Addendum Number: 01

Addendum Issue Date: April 17, 2025

Project Name: Robinson Washington Elementary
Renovation & Addition

Project Number: 02401781.001

E1.0

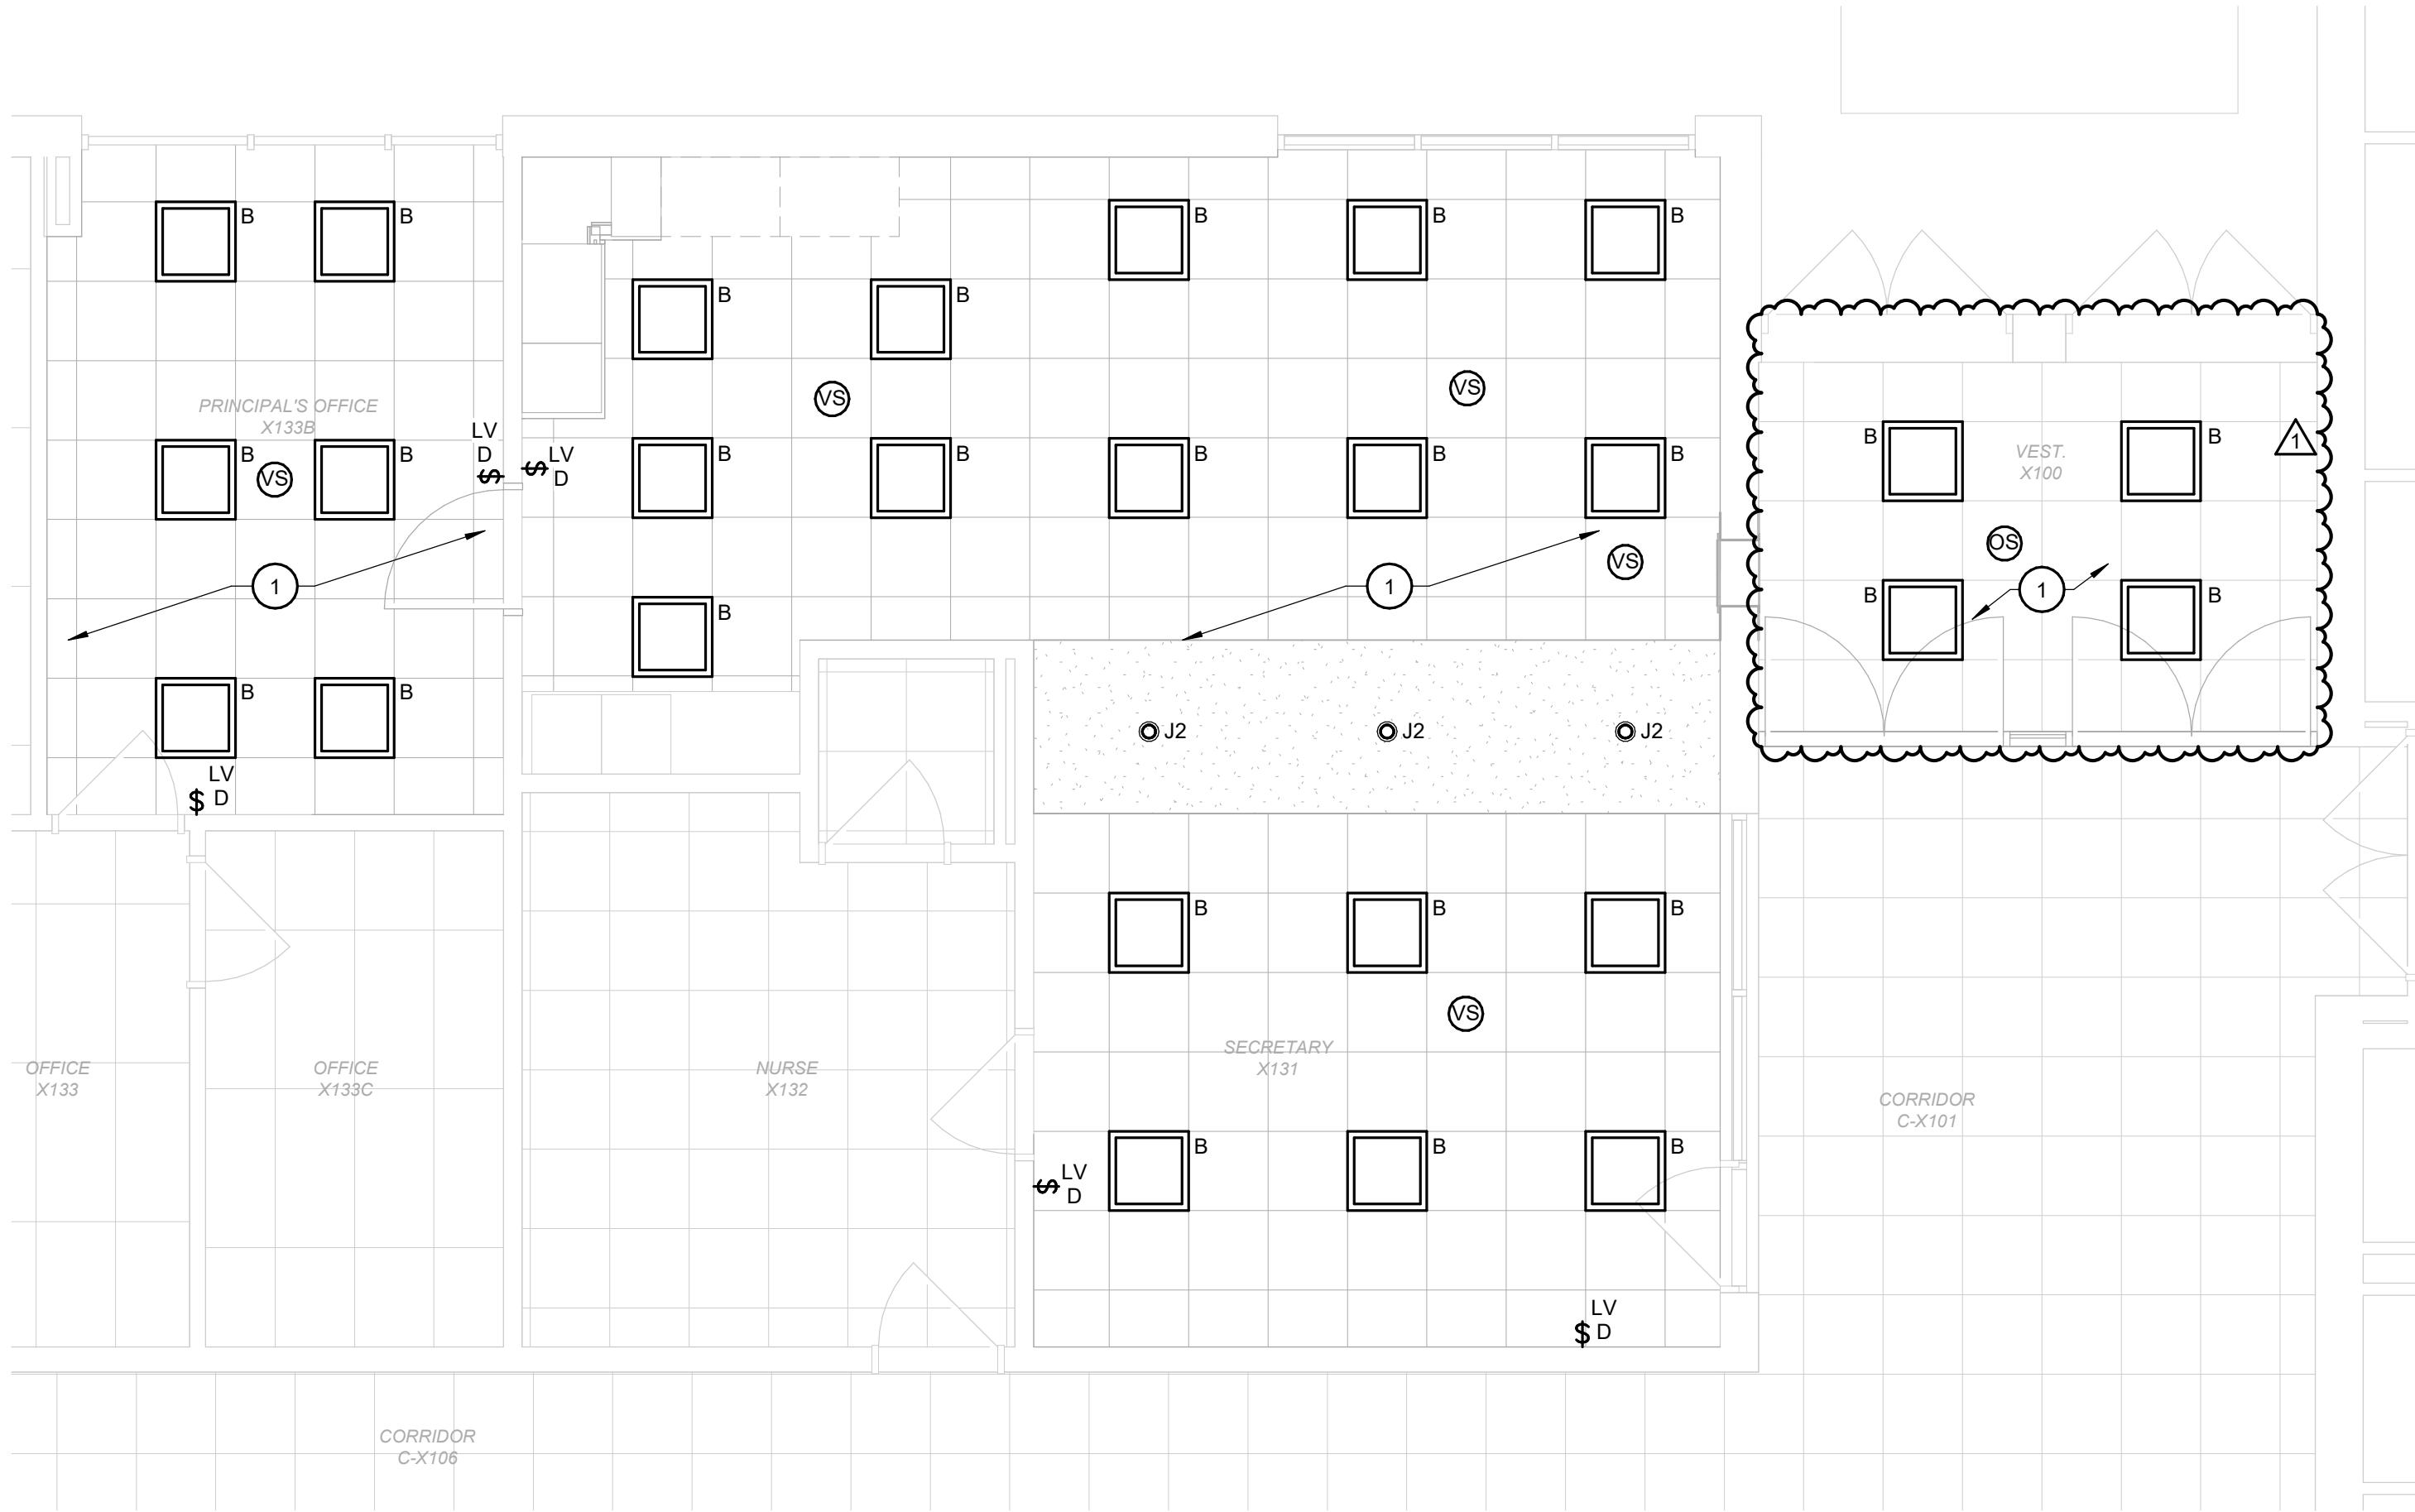
- a. ADD type B luminaires, occupancy sensor, and keynote #1 to Vest. X100. See attached sheet.
 - b. REVISE keynote #1. See the attached sheet.
43. E2.0 – FIRST FLOOR POWER PLAN – AREA EXISTING

1 FIRST FLOOR POWER PLAN - AREA EXISTING
SCALE: 1/16" = 1'-0"

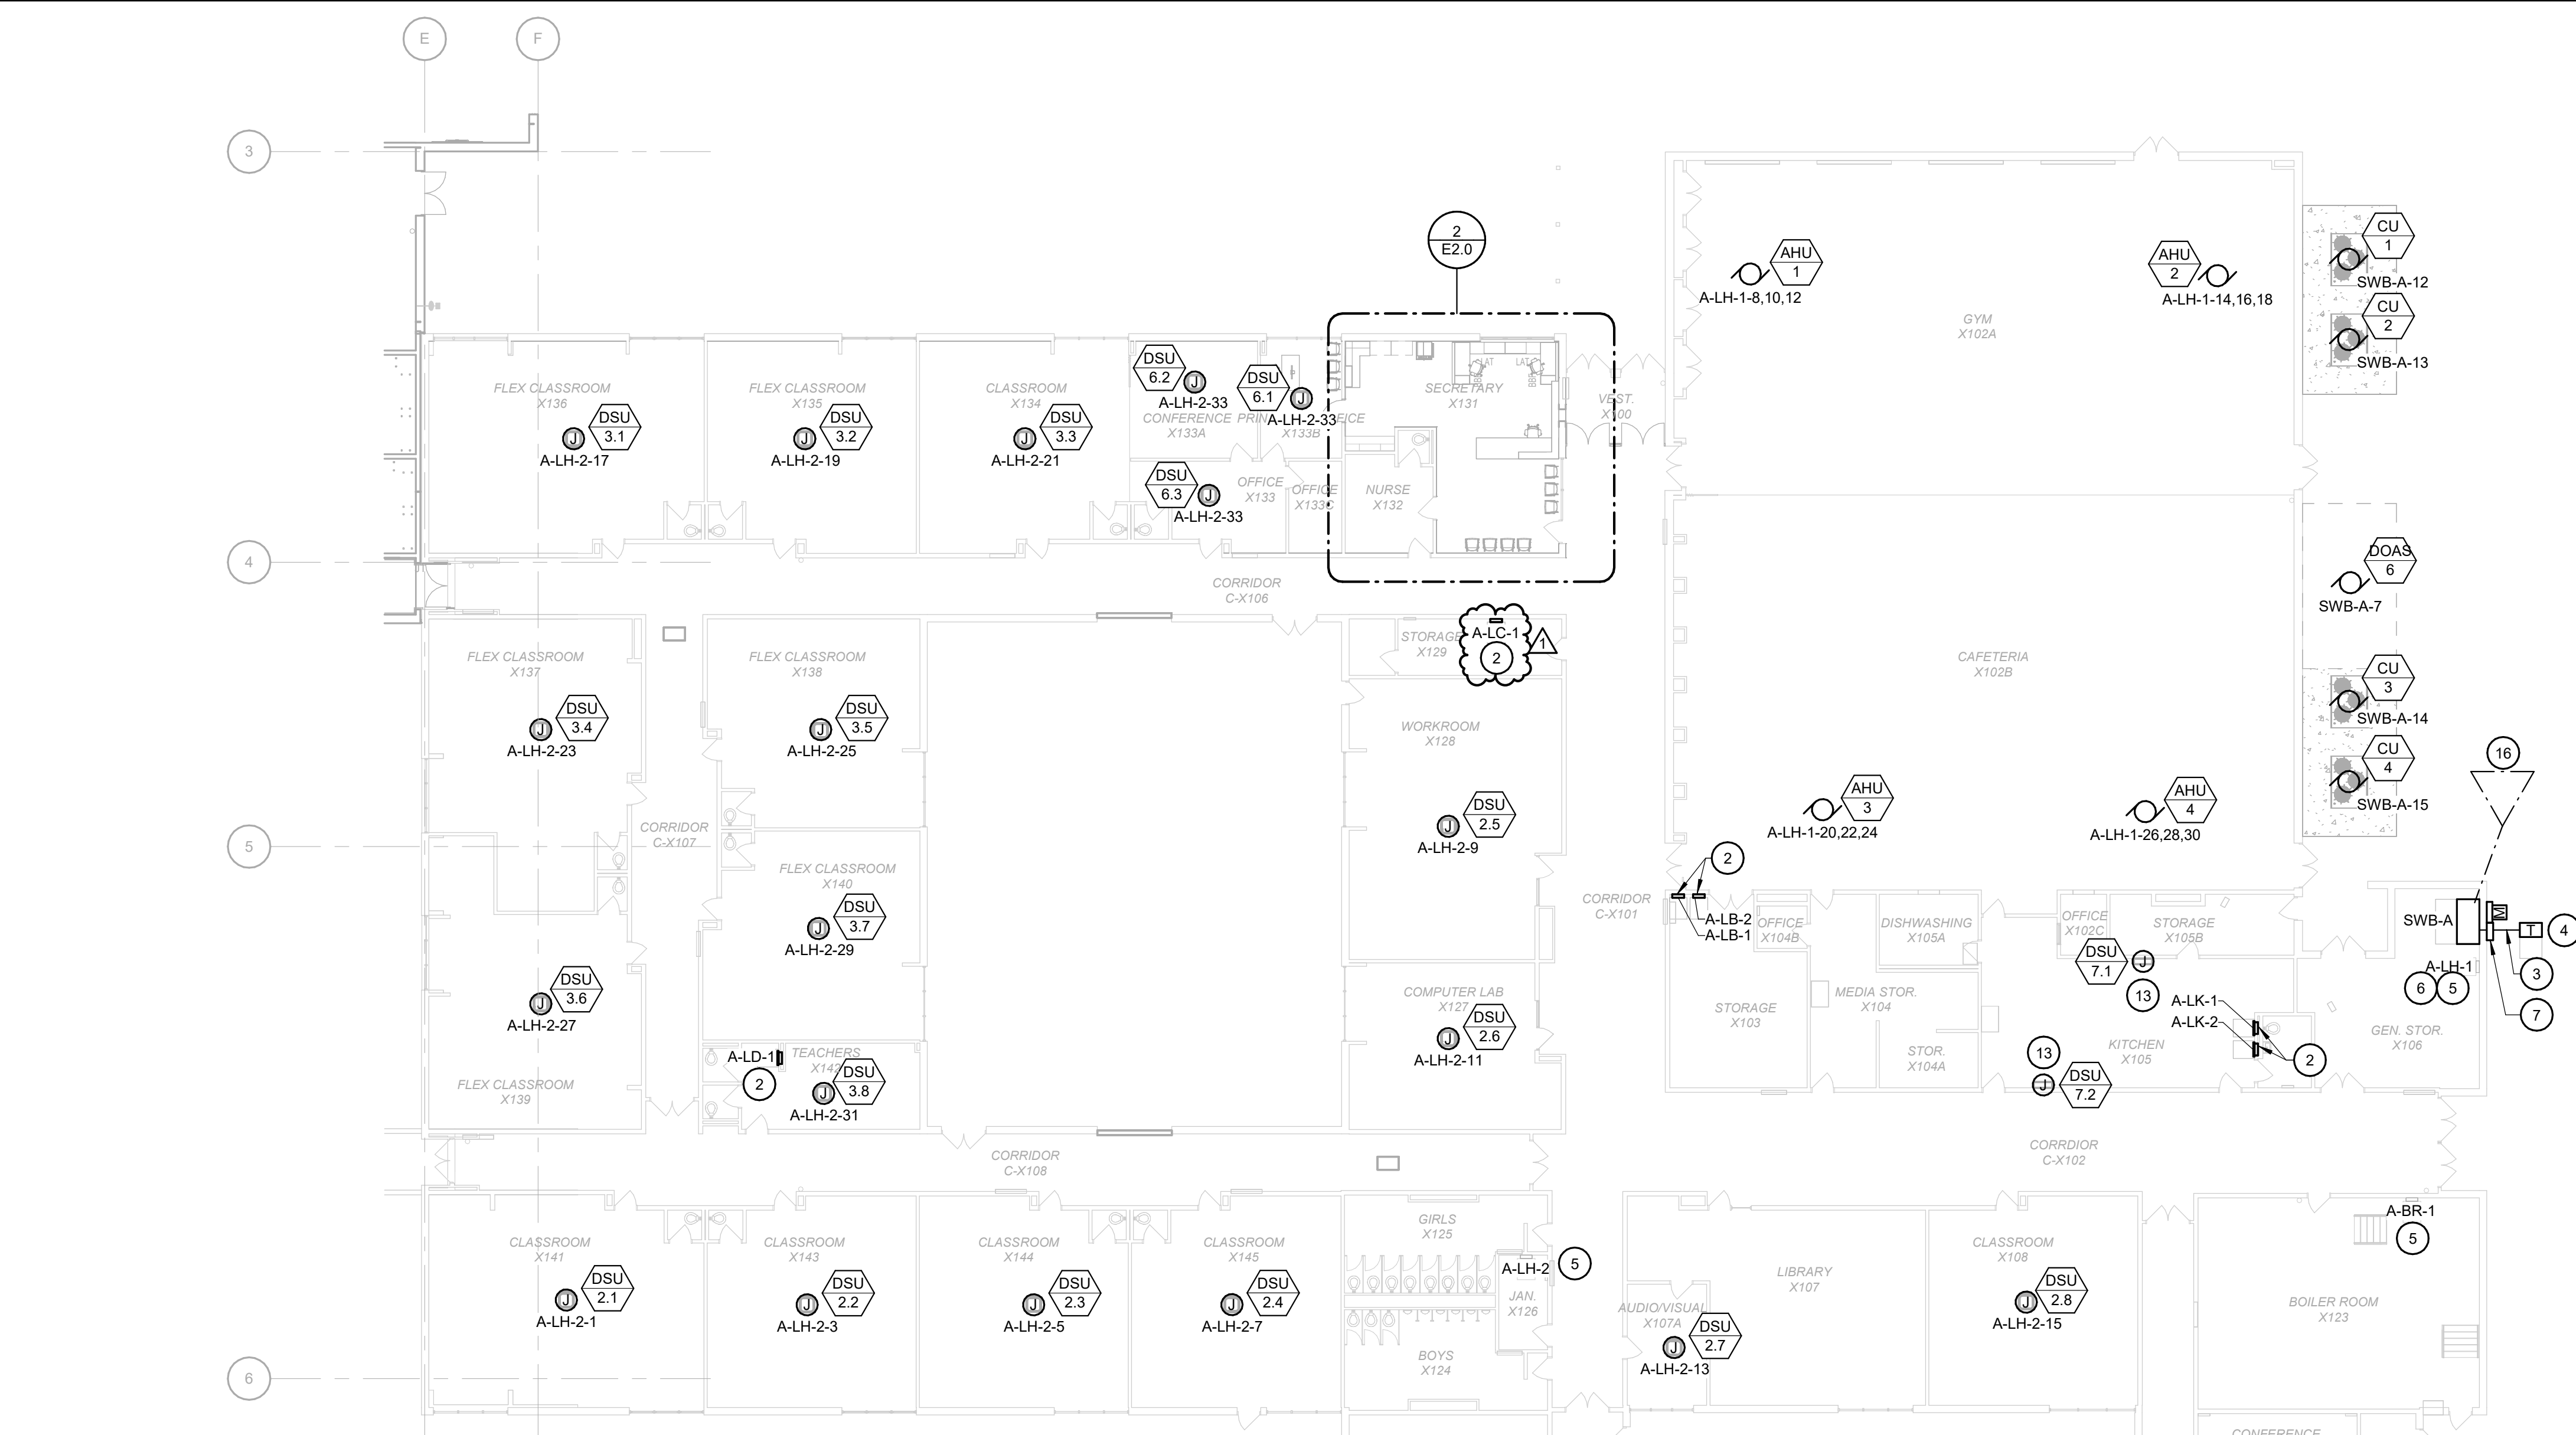
- a. REVISE panel C to be surface mounted. See attached sheet.
 - b. REVISE keynote #1 to not be used. See attached sheet.
44. E3.1 – FIRST FLOOR SYSTEMS PLAN – AREA A

FIRST FLOOR
SYSTEMS PLAN -
AREA A

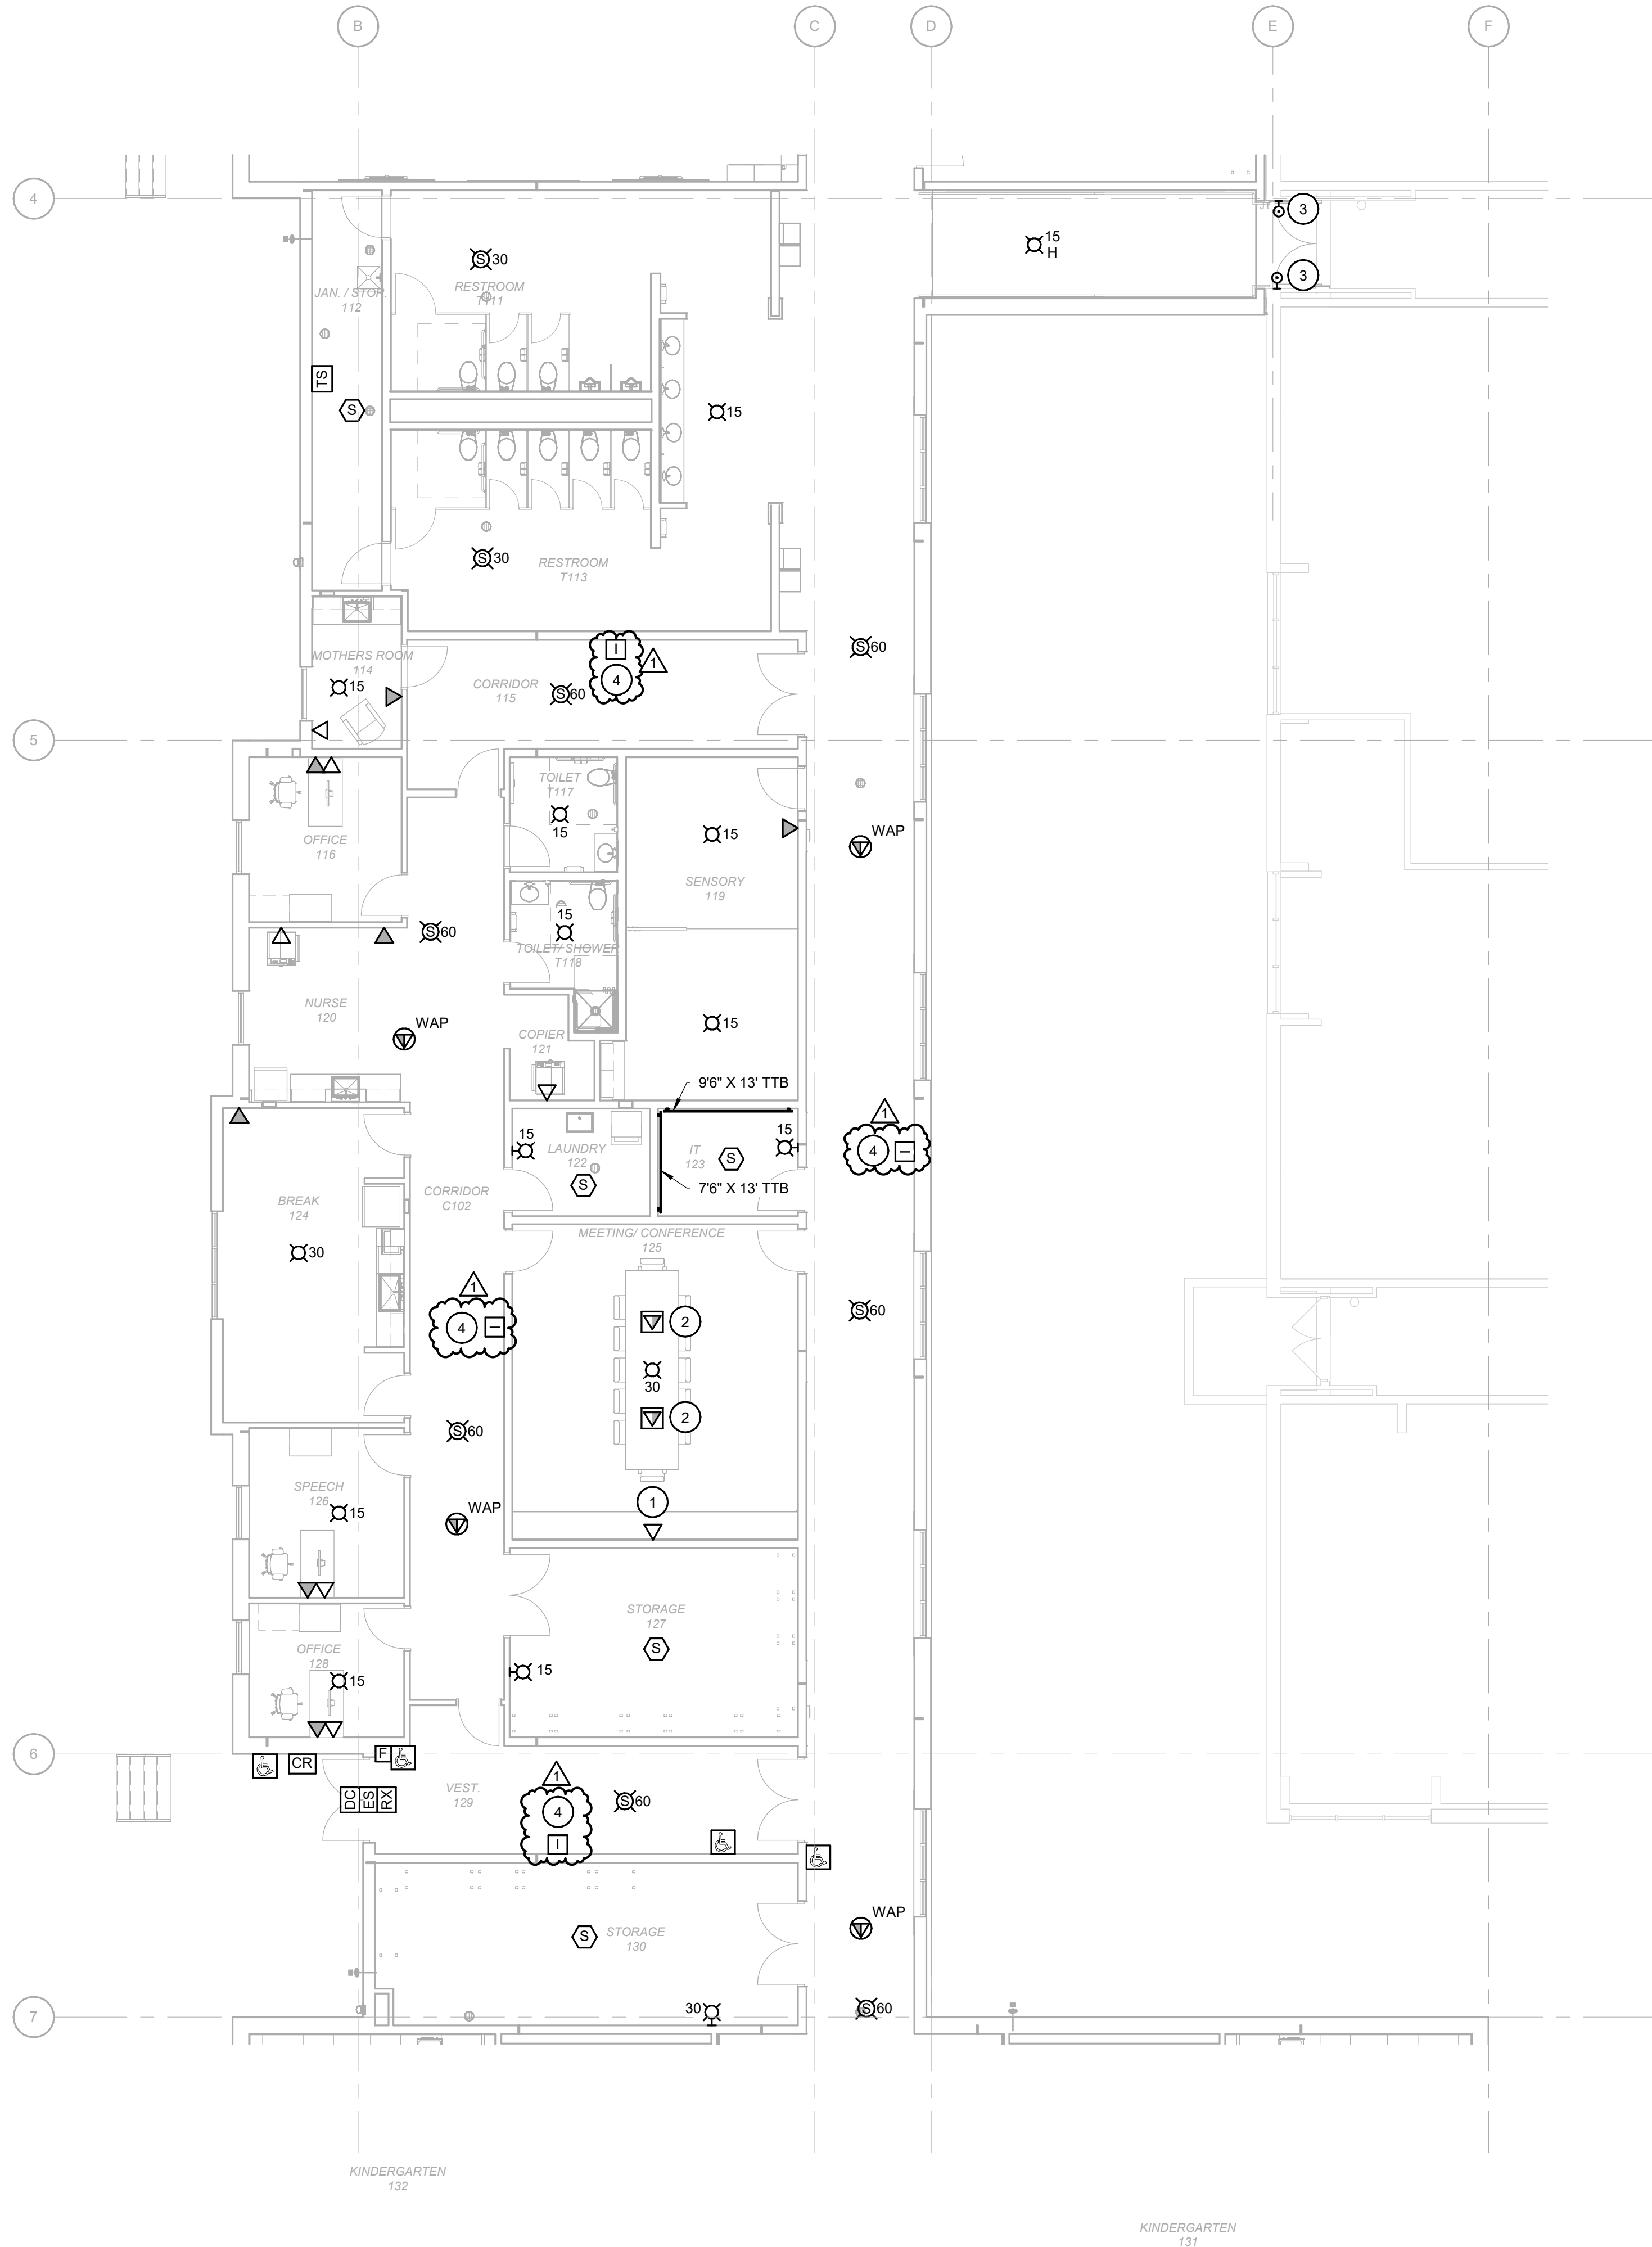
- a. ADD intercom locations. See attached sheet.
45. E3.2 – FIRST FLOOR SYSTEMS PLAN – AREA B
- a. ADD intercom locations. See attached sheet.
 - b. ADD keynote #4 for intercom locations. See attached sheet.
